COMMUNITY DEVELOPMENT DEPARTMENT REPORT

SUBJECT: Storyrock – AZ, MDA, PP, RZ
H-2025-0025

LOCATION: Generally located on the south side of W. Amity Rd., midway between S. Meridian Rd./SH-69 and S. Linder Rd., in the north 1/2 of Section 36, T.3N., R.1W

STORYROCK SUBDIVISION
 MERIDIAN, ID
 PRELIMINARY PLAT LANDSCAPE PLAN

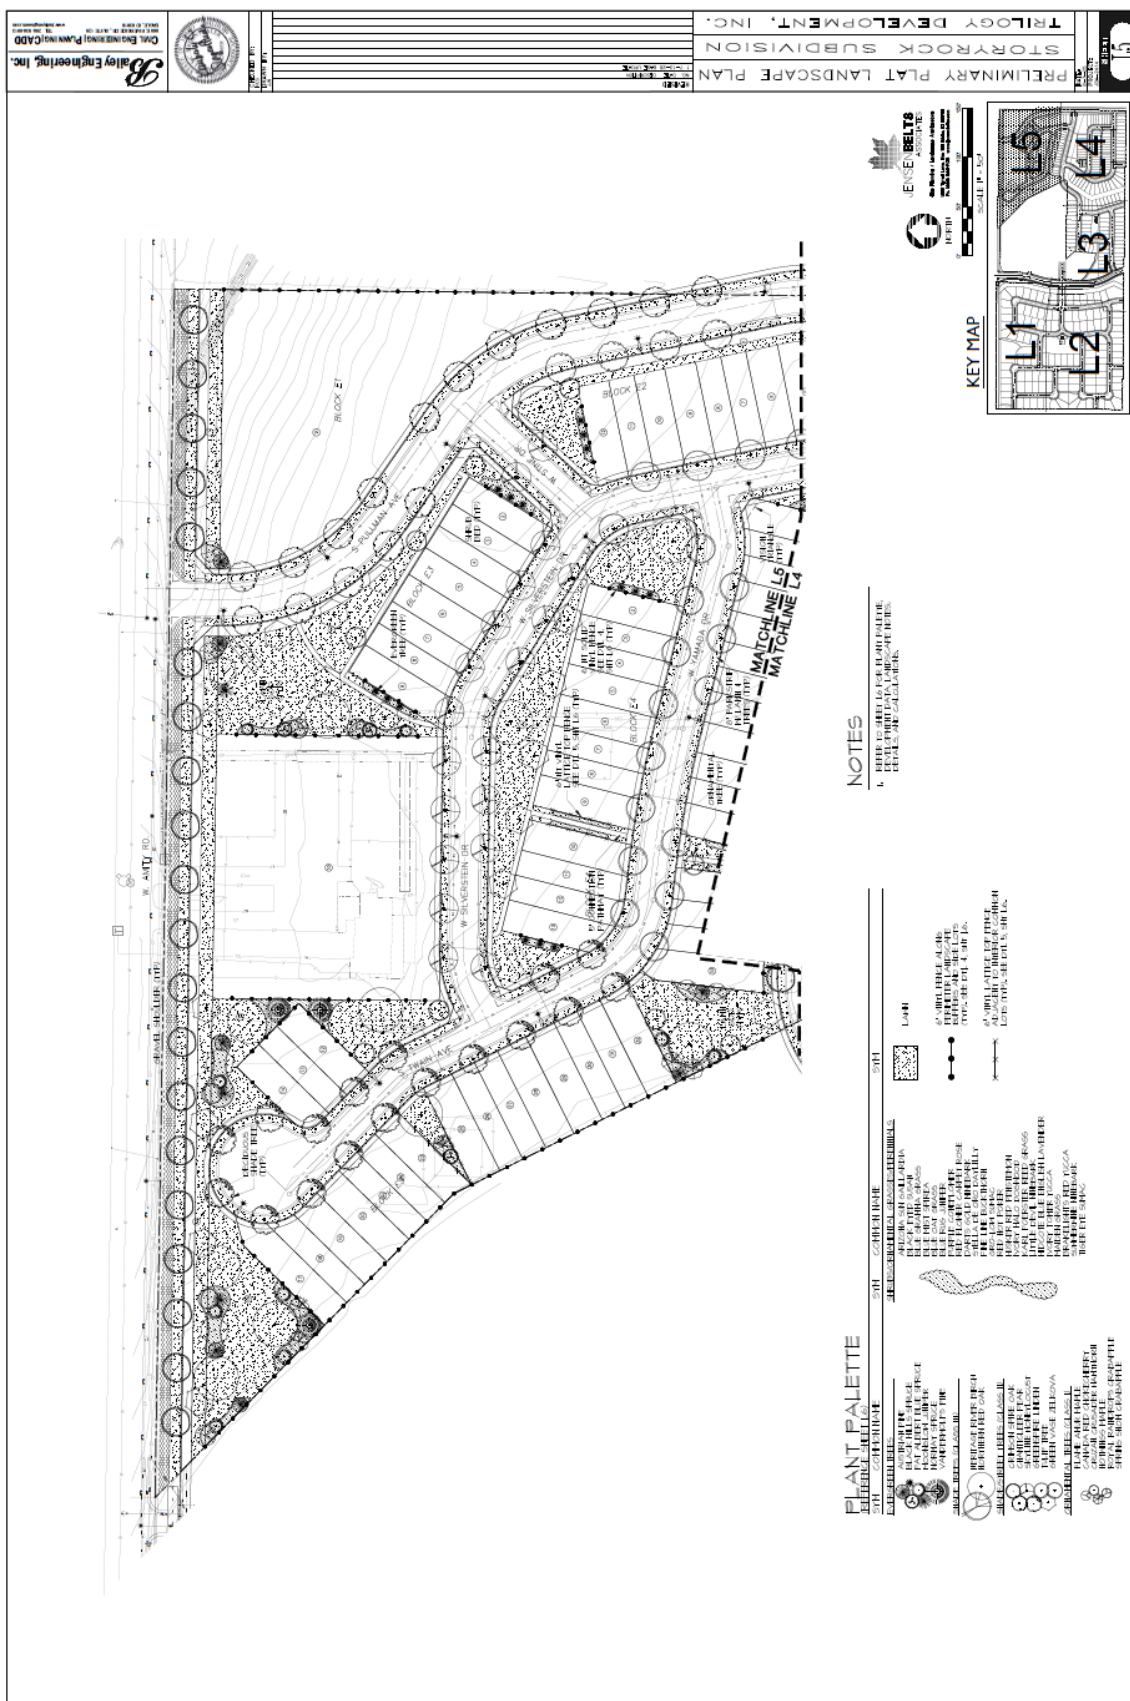
The street buffers along W. Amity Rd. (arterial) and S. Oakbriar Way (collector) are required to comply with the enhanced buffer requirements in UDC 11-3G-3B.3 and 11-3B-7C.3f in order to count toward the qualified open space requirement. Details should be included on a revised landscape plan explaining what enhanced buffer elements are proposed.

The Landscape Calculations table on the landscape plan should include the following: length and width of the street buffer and tree classifications for S. Oakbriar Way, Pullman Ave. (if designated as a collector street) and road through Lot 10, Block E3; length and width of parkways (aka residential subdivision trees) and the required vs. provided number of street trees and tree classification.

At a minimum, common open space areas should include one (1) deciduous shade tree for every 5,000 square feet of area and include a variety of trees, shrubs, lawn or other vegetative groundcover. **The square footage of common areas and the required number of trees should be included in the Landscape Calculations table on the landscape plan.**

The landscape strips are required to be planted with a mix of trees, shrubs, lawn, and/or other vegetative groundcover. A minimum of one (1) tree per 100 linear feet of pathway is required. **The length of pathways and required vs. proposed number of trees that demonstrate compliance with the standards in UDC 11-3B-12C should be included in the Landscape Calculations table.**
